SUBJECT: Donald C. Cook Nuclear Plant Unit 1
Docket No. 50-315
Response to Request for Additional Information Regarding the Reanalysis of Unit 1
Small Break Loss-of-Coolant Accident

Enclosure 1 to AEP:NRC:8046

Figure 6-1

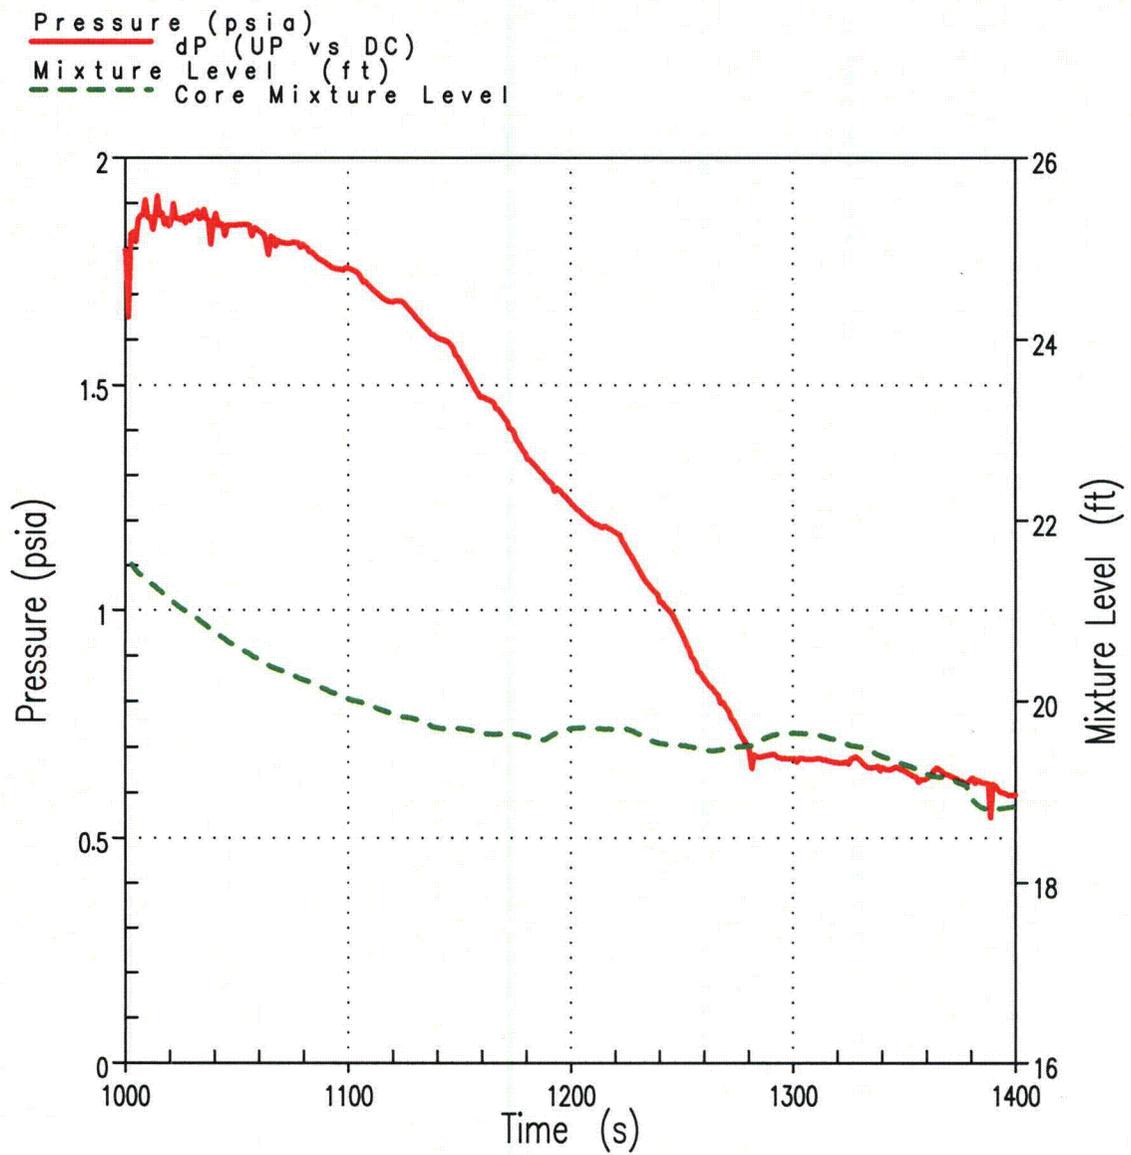
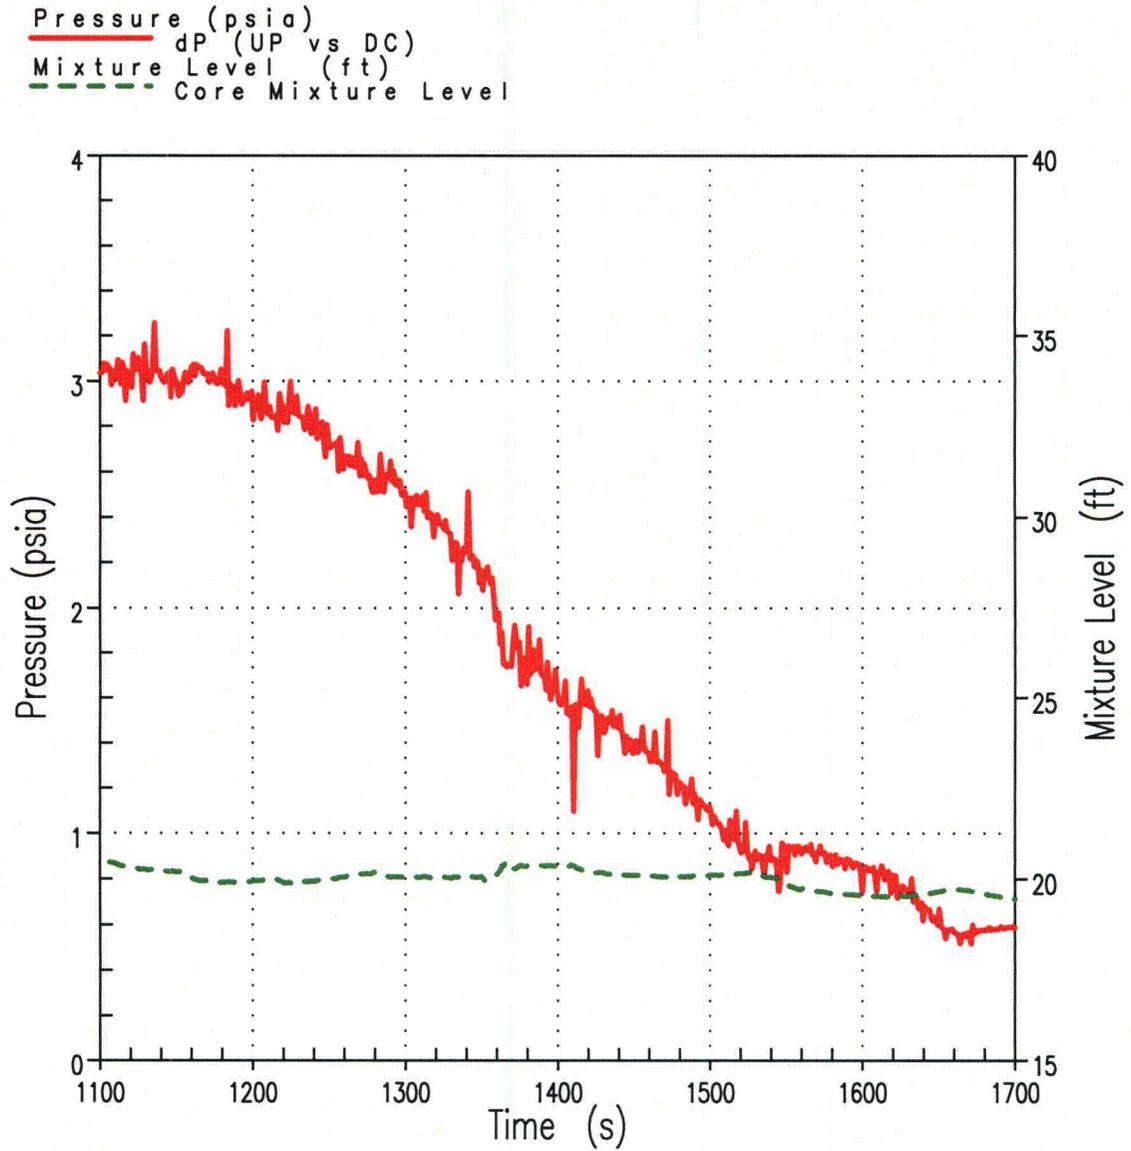
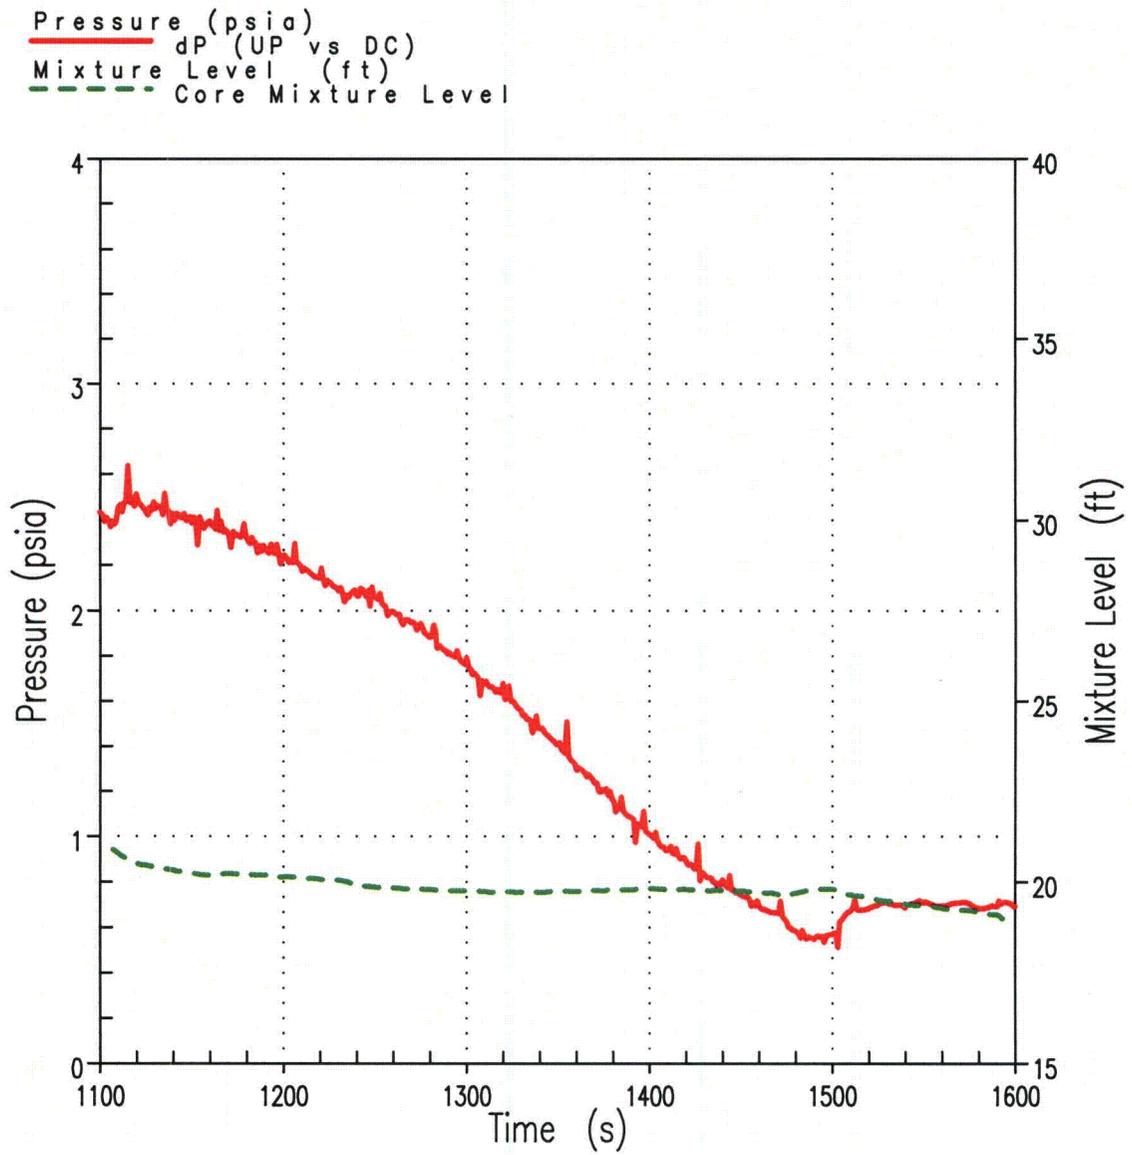
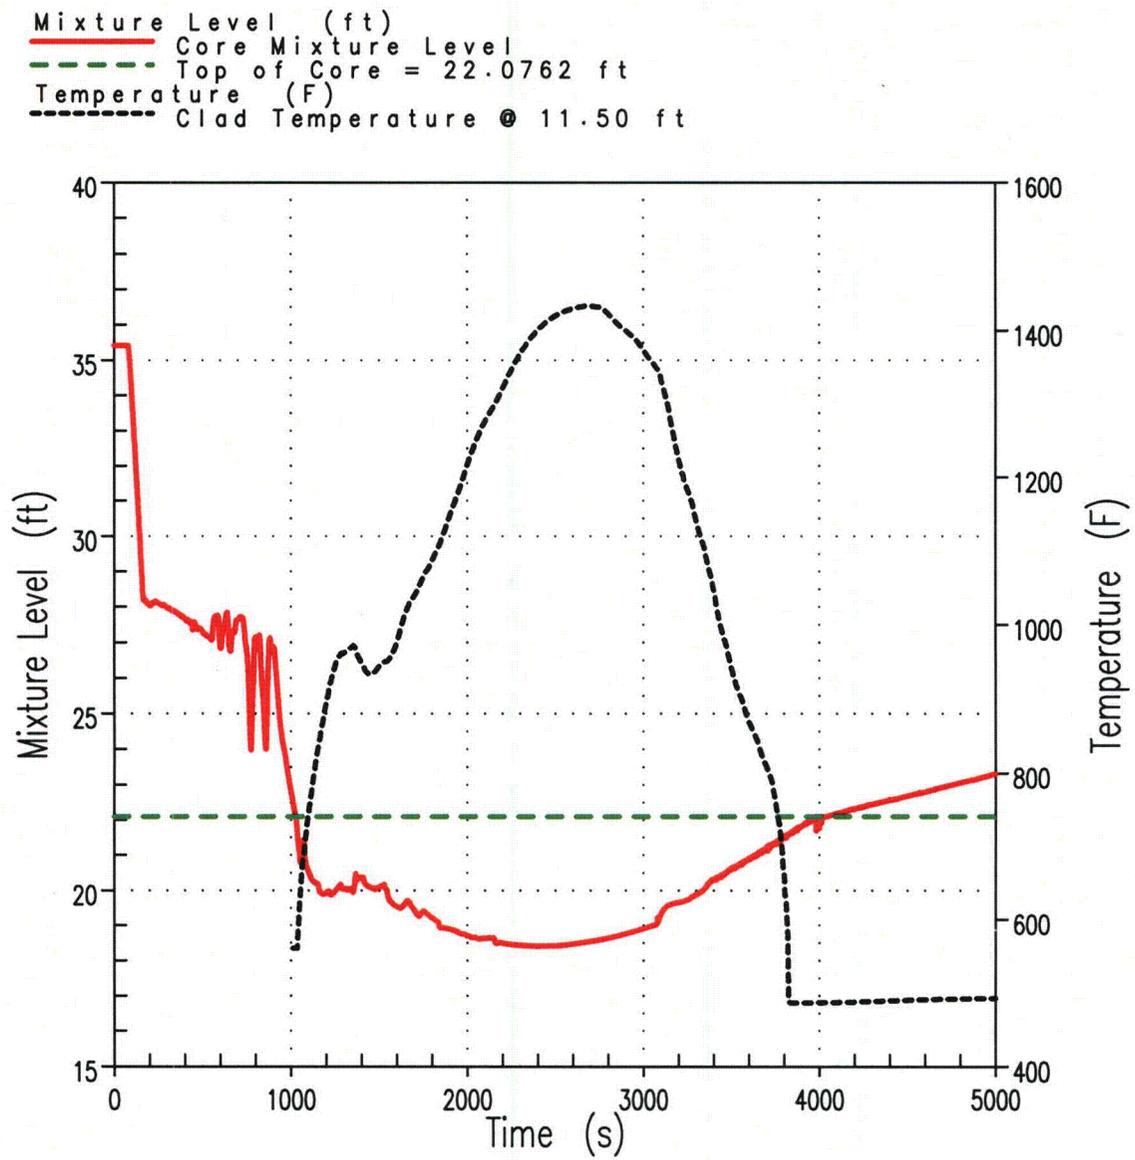
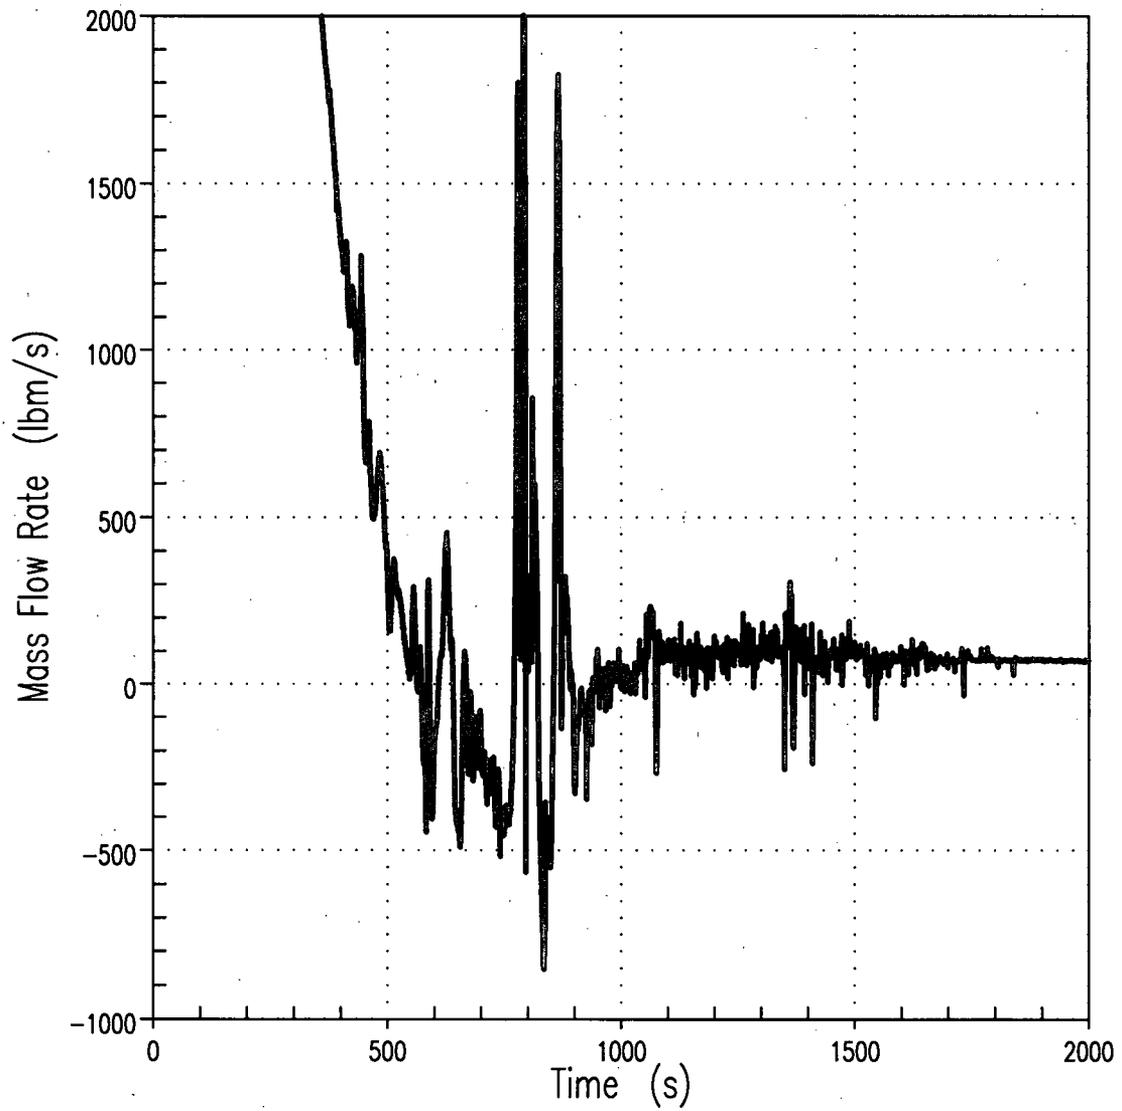
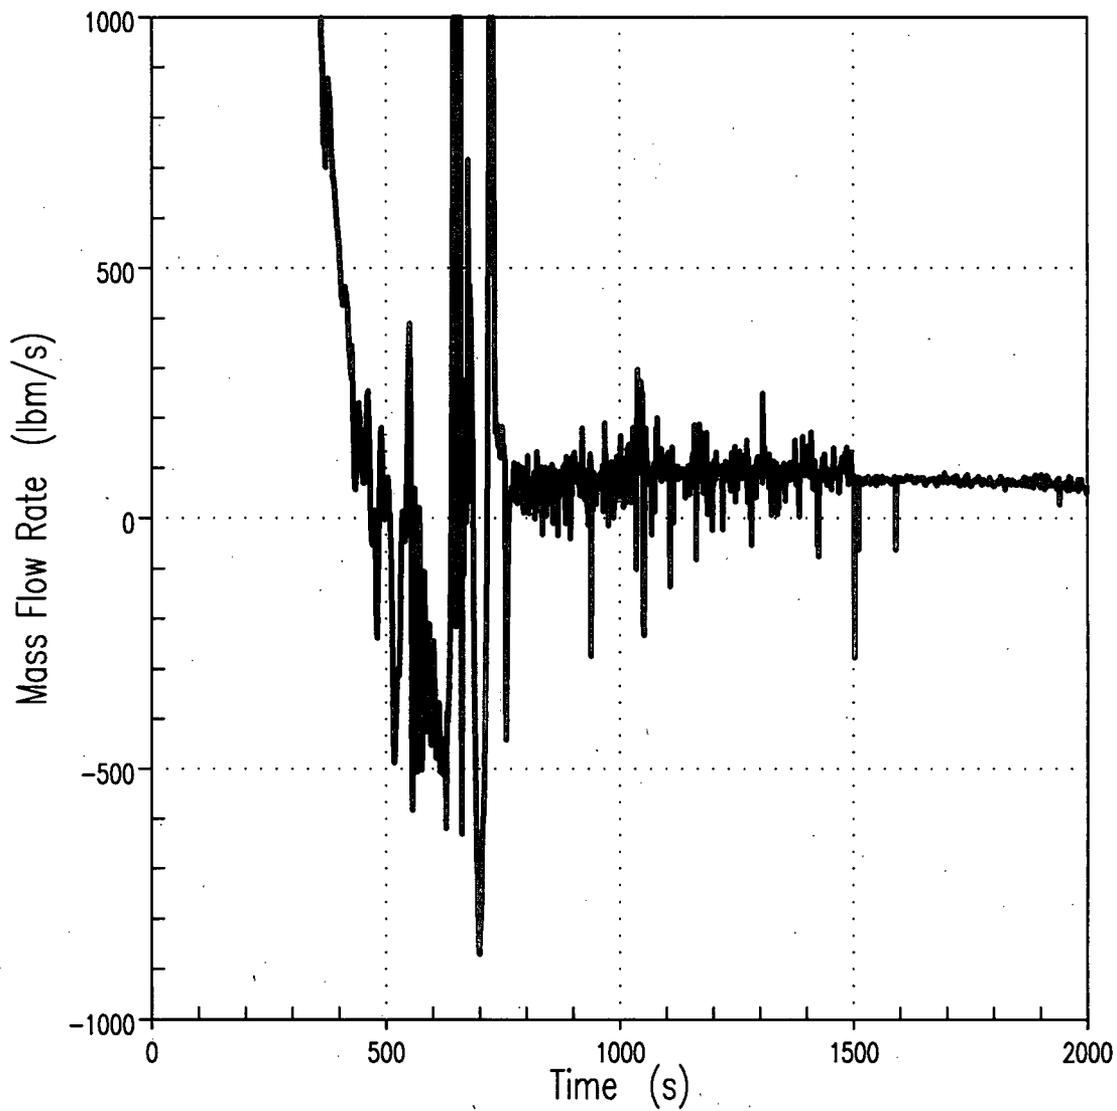
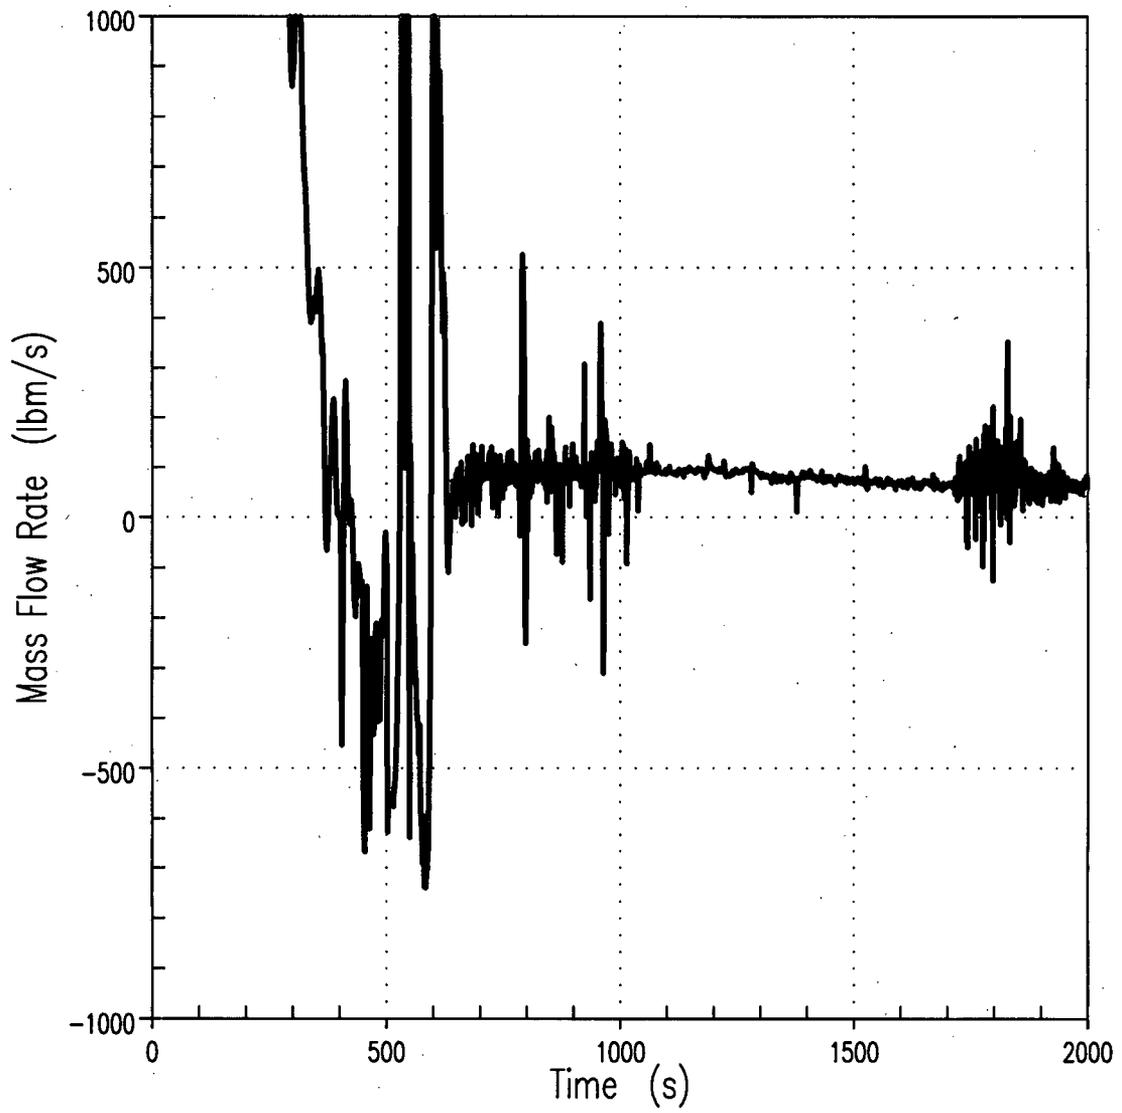
Please explain the termination in the core two-phase level for the 3-inch break from 1000 to 1300 seconds in Fig. 28 for the 3-inch break. The 2.5-inch break has a similar behavior from 1200 to 1500 seconds in Fig. 25 as does the 2.5-inch break from 1100 to 1600 seconds in Fig. 22. Please explain the abrupt deviation from the boil-down and initial rapid loss of level behavior for these breaks. The froth-up behavior for the 2.5-inch break terminates and cools the hot spot during this period and does not appear physical. Please also provide the liquid mass and core inlet flow rates vs. time for these breaks.

The core mixture level termination seen in the 2.5-, 2.75-, and 3-inch breaks can be attributed to the steady decrease in pressure differential between the UP and the DC at the same time, as seen for the 3-inch break case in Figure 6-1. A similar behavior also occurs for both the 2.5- and 2.75-inch breaks. Note that, as the break size decreases, this differential pressure effect becomes more pronounced as can be seen in Figures 6-2 for the 2.5-inch case and Figures 6-3 for the 2.75-inch case.

The froth up behavior seen at 1400 seconds in the 2.5-inch break case can be attributed to the mixture level variations during that time which causes a corresponding peak in the PCT at this time as seen in Figure 6-4.

The core inlet flow rates versus time for the 2.5-, 2.75-, and 3-inch breaks are provided in Figures 6-5, 6-6, and 6-7, respectively. The total core liquid mass for the 2.5-, 2.75-, and 3-inch breaks are provided in Figures 6-8, 6-9, and 6-10, respectively.
